Economic Commission for Europe

Informal Ad hoc Expert Group on Conceptual and Technical Aspects of Computerization of the TIR Procedure

Approved amendments to the eTIR conceptual, functional and technical documentation - v.4.2a

Note by the secretariat

Figure 3
Guarantee status chart diagram

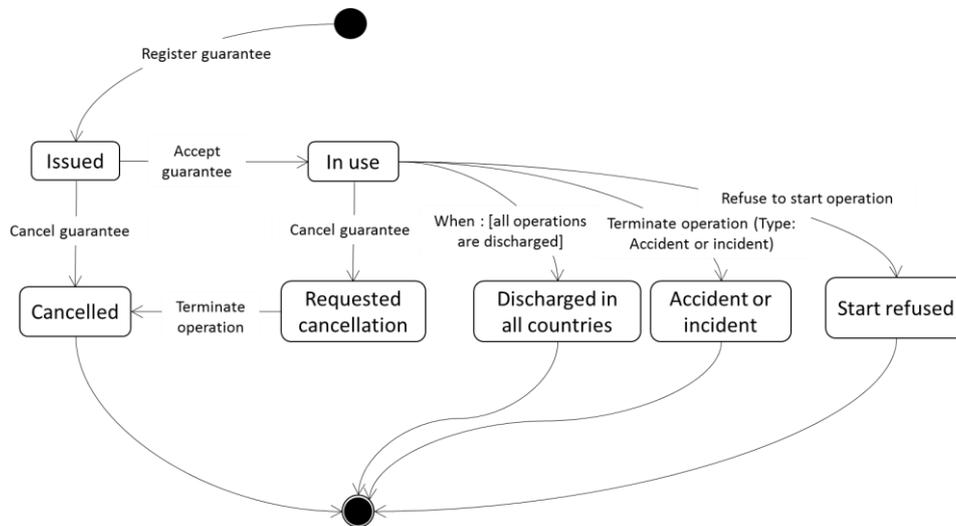
4. GE.1 took note that the status of the guarantee could not remain “in use” in case of accidents or incidents nor in the case of a refusal to start a TIR operation. Consequently, it requested the secretariat to introduce two new codes for the guarantee status and the corresponding rules for the eTIR international system in the next version of the eTIR specifications.

5. As a result, in the next revision of the eTIR specifications, the code list CL22 will be as follows:

CL22	Guarantee status (eTIR)
001	Issued
002	In use
003	Cancelled
004	Requested cancellation
005	Discharged in all countries
006	Accident or incident
007	Start refused

6. Chapter “3.1.2 Guarantee state chart diagram” of the eTIR concepts document will list the two additional guarantee statuses.

7. Figure 3 in the same document will be amended as follows:

1.3.3.2 Customs offices database

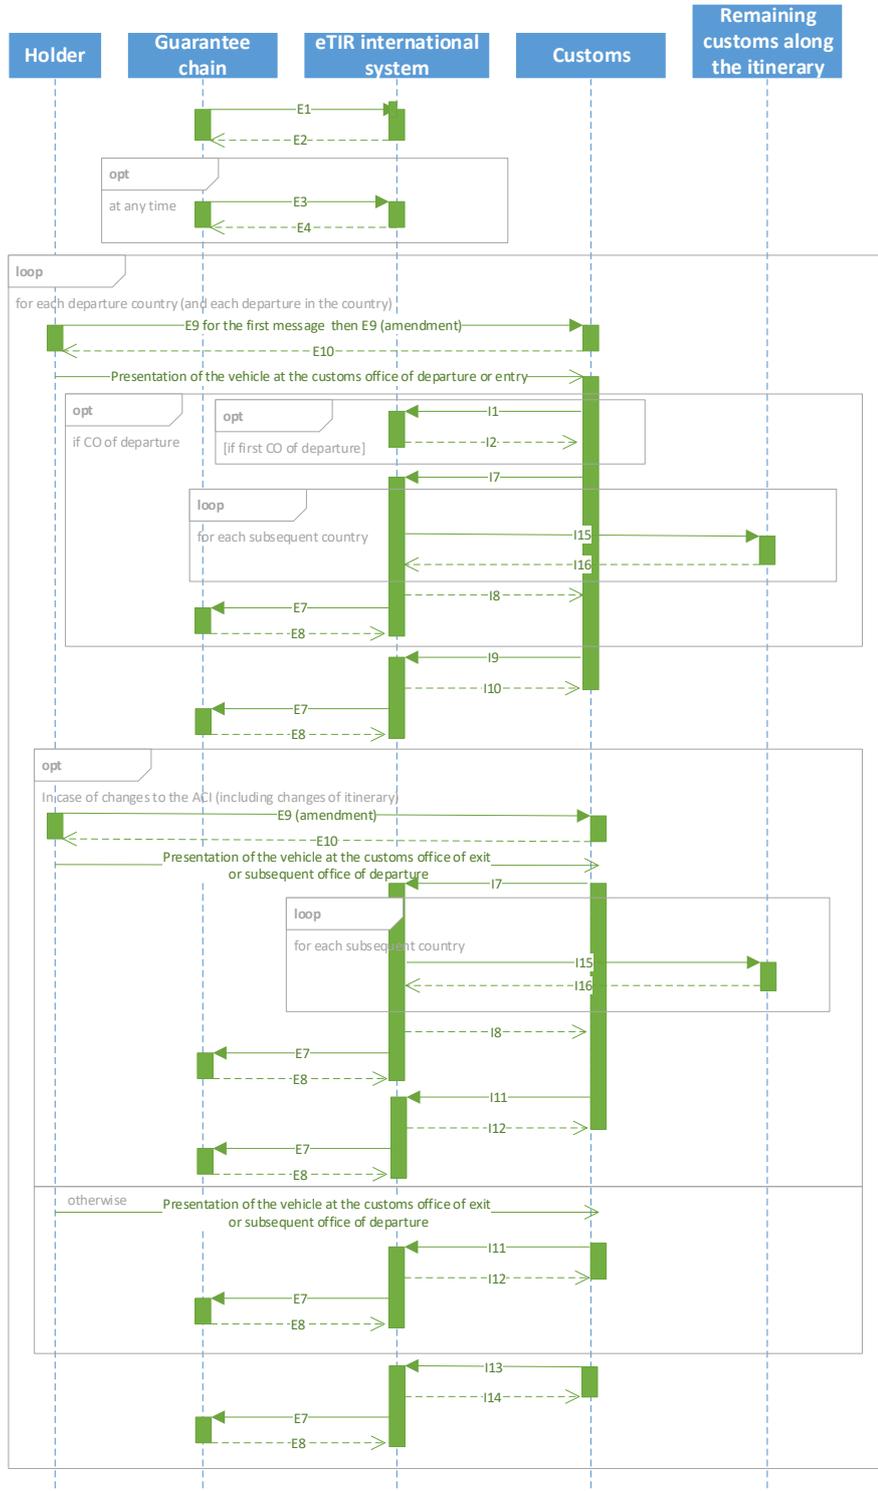
22. The following changes should be made to the eTIR concepts document (ECE/TRANS/WP.30/2020/2, para. 21):

- delete the customs offices database from the eTIR international deliverables and add instead a new chapter to Chapter 1.3.3 (Other required systems), as it is the case for the database on TIR Carnet holders contained in the ITDB. The new chapter could read as follows:

To ensure that customs offices are approved for eTIR, the eTIR international system retrieves the necessary information from the ITDB using a web service.

a. Message sequence for countries of departure

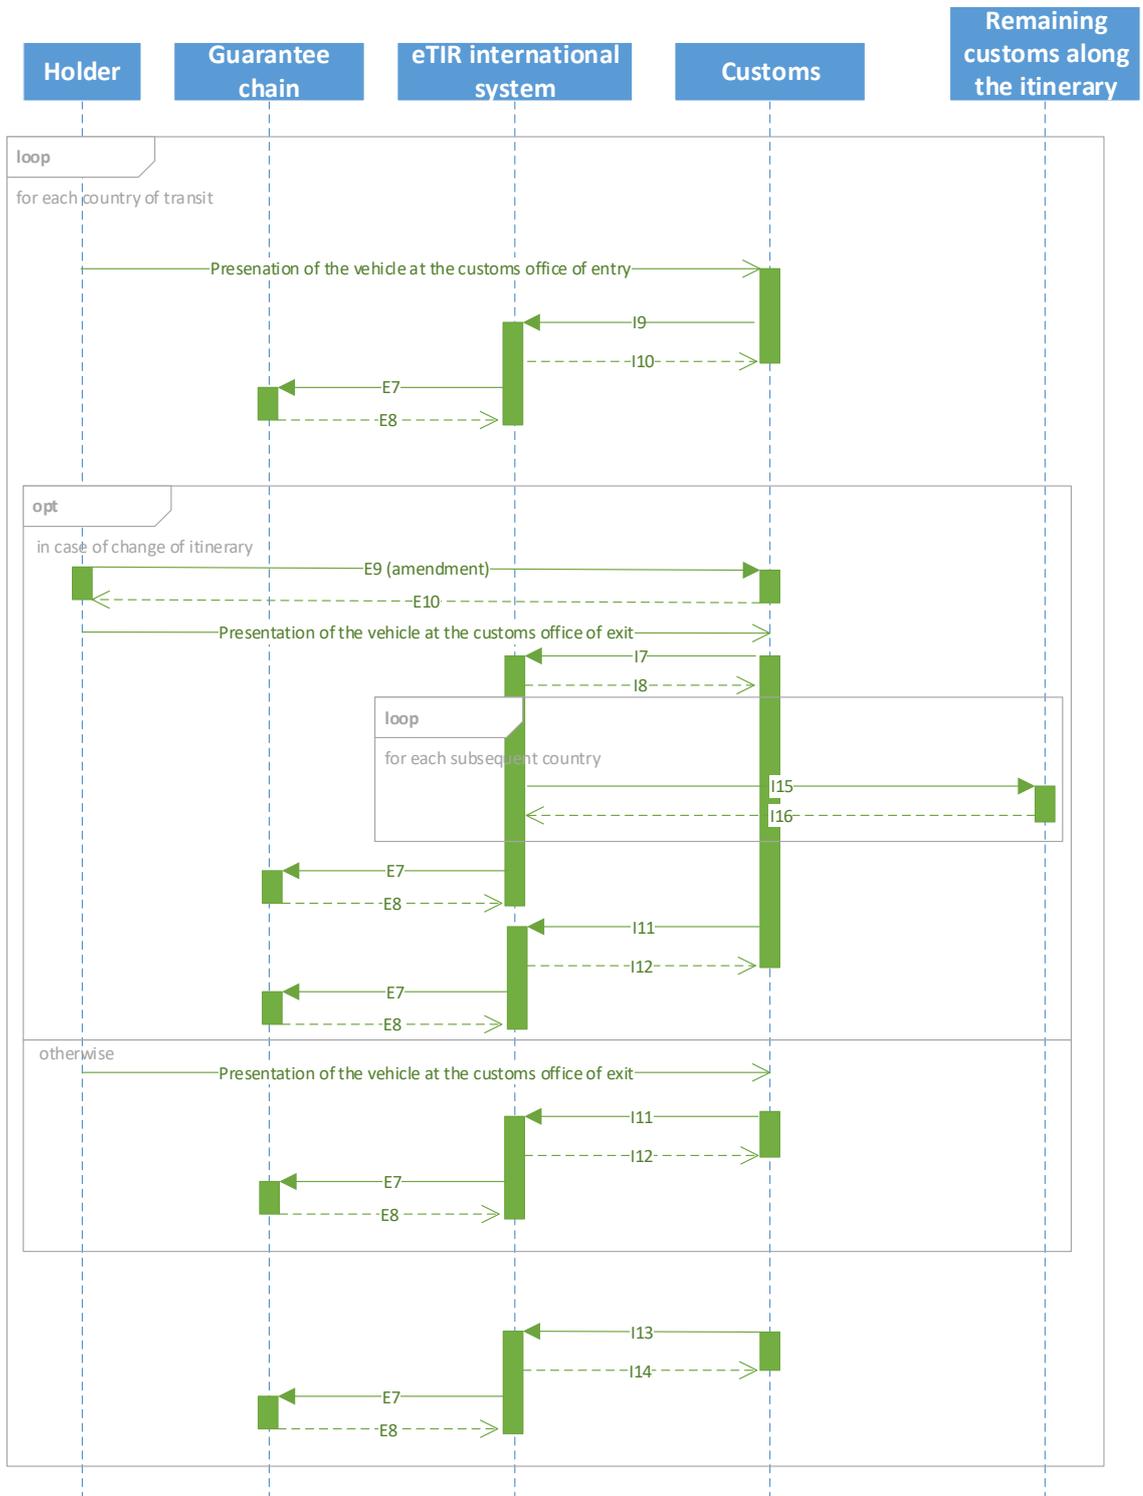
3. The sequence diagrams describing the standard sequences of eTIR messages for countries of departure, transit and destination (as contained in Annex I) will be included in the next revision of the eTIR functional specifications as a new Annex.
